hrt MSB306-37/2+320-08/2
Page 1 of 5
attsies 13 August 2003
Supersedes issue dated 13 June 2003

SERVICE BULLETIN NO. MSB306-37/2 MSB320-08/2

Modification of the Canopy Jettison System

1.8.2 The canopy jettison operating lever including operating cable must be removed as follows (refer to illustration on page 4):

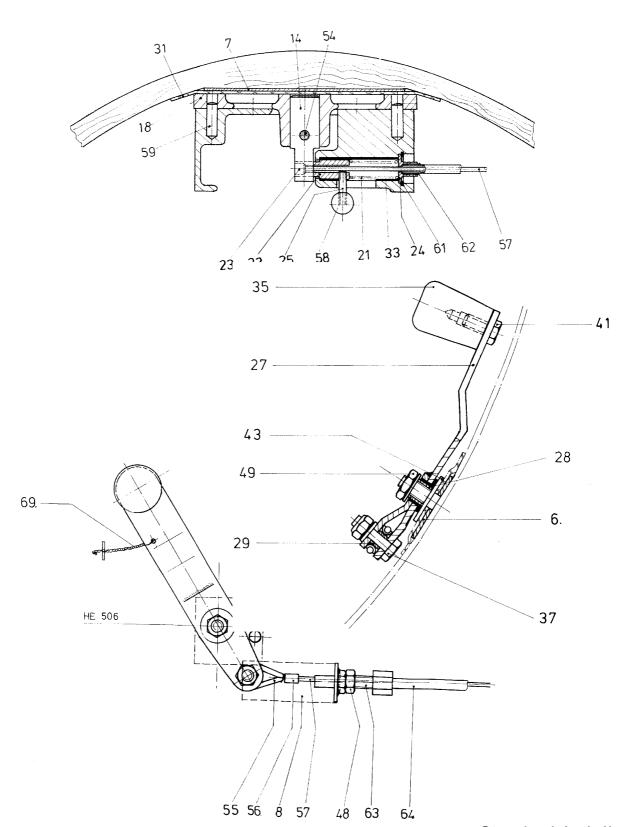
- remove the RH cockpit covering
- remove bolt (37)
- cut-off cable (57) and remove adjusting screw (48) and remove completely operating cable (64)
- remove safety wire (69)
- remove nut (49) and operating lever (27)
- cut-off cable (57) from canopy joint
- remove cable rest with socket (62) and nipple (23)
- install RH cockpit covering
- remove placard "Canopy Jettision" from canopy jettison operating lever

NOTE: The canopy can be removed for maintenance purposes by operating the red ball knob (58)
